GEOCRES No. 3165-189

LOCATION Woodroffe Ave. Underpass

DISTRICT 9  
CONT No  
WP No 118-86-01  
RETAINING WALLS UNDER  
WOODROFFE AVE. STRUCTURE  
DETAILS  
McCORMICK RANKIN  
CONSULTING ENGINEERS

DISTRICT 9	
CONT No	
WP No 118-86-01	
CONCRETE SLOPE PAVING WOODROFFE AVE. STRUCTURE DETAILS	SHEET 75
McCORMICK RANKIN CONSULTING ENGINEERS

SHEET  
74

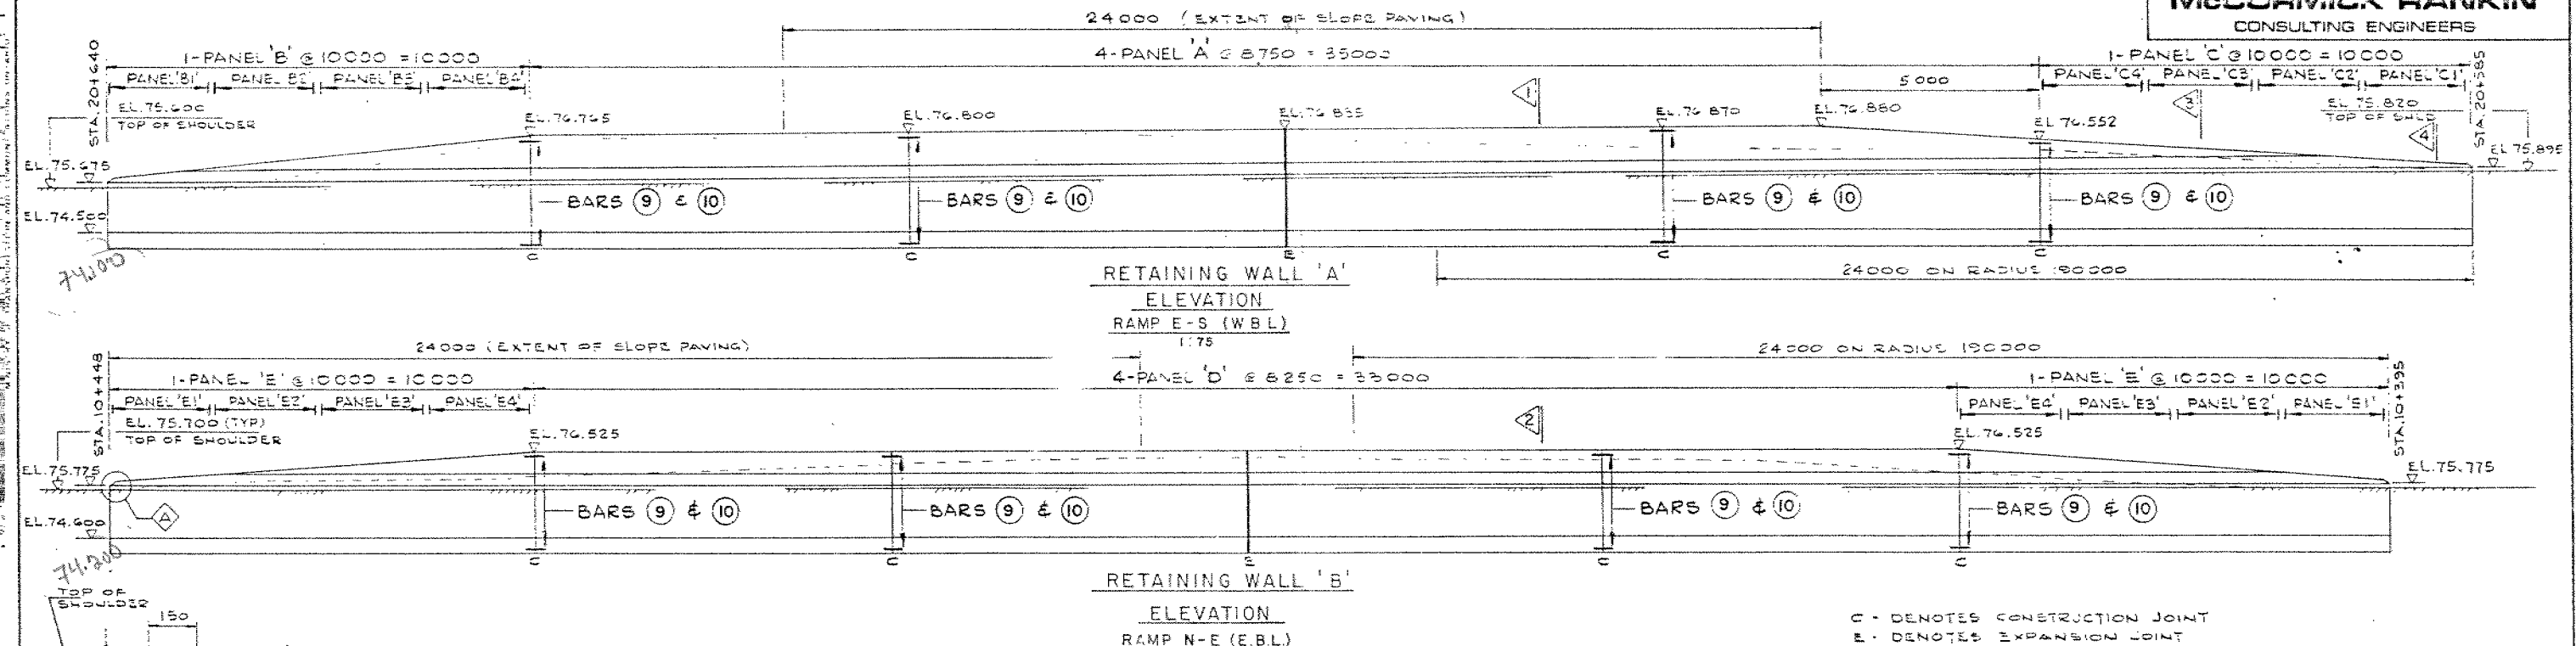
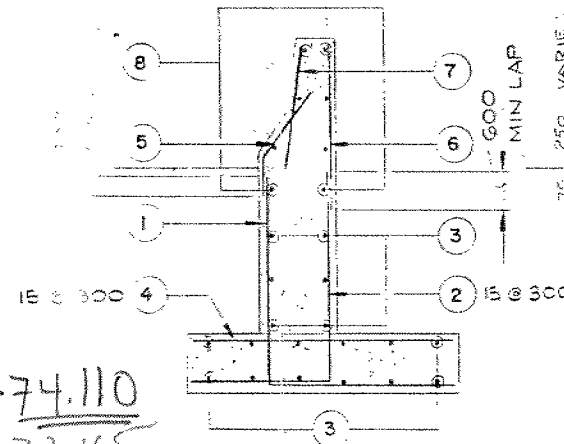
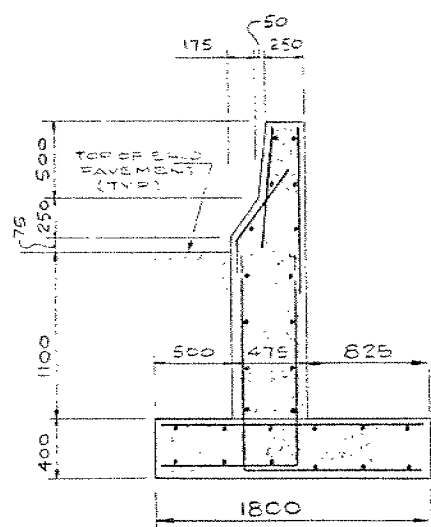
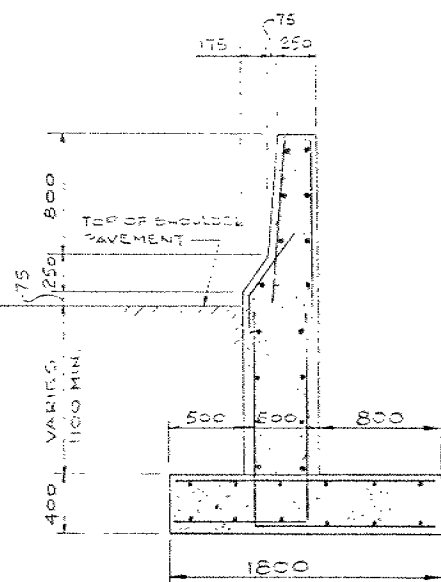
NO PLANNING  
SHOWN, HOW TO  
LAYOUT IN FIELD?

This Section has reviewed the revised contract drawings (sheets 74 and 75) and the following geotechnical related comments are provided.

There are no sections or details provided for the foundations of the tapered retaining walls which are illustrated as shallow foundations for retaining wall 'A' and at the west end of retaining wall 'B'. It is assumed that these concrete toe walls are to be designed and constructed according to OPSD-513.03 and associated specifications. The frost protection illustrated on this standard drawing is substantially lower than the 1.8 m frost penetration depth in the Ottawa area. The structural consequences of differential frost heave and thaw cycles should be considered.

In response to McCormick Rankin Consulting Engineers letter dated November 23, 1988, this section has reviewed the revised design drawings (Sheet 74 and 75) pertaining to the aforementioned structure and the following comments are provided.

It appears that there has been a misinterpretation concerning allowable soil pressures, and associated deflection restrictions. Contrary to the statement 3(iv) provided in McCormick Rankins letter, deflection restrictions should NOT be neglected and in accordance to Limit States Design, the maximum deflection at S.L.S. Type II, should be restricted such that the proper function of the structure is not impaired. Consequently, the maximum deflection allowable is restricted to 25mm. This constant deflection parameter should be employed in calculating allowable loadings. If it is determined that these loadings exceed the factored capacity at U.L.S. (Factored Capacity =  $0.5 \times$  Ultimate Lateral Resistance), then the factored capacity at U.L.S. governs design. Otherwise, the loadings deduced in conjunction with the specified deflections shall govern design.

- (a) We have added notes on the drawings to clarify that the low tapered sections of the toe-walls not supported on caissons are unreinforced, and to identify the dimensions for the toe-wall cross-sections in these areas.
- (b) As an added precaution to mitigate any adverse effects of frost heave on the underside of the toe-walls between caissons, we have added 25 mm of expanded polystyrene.
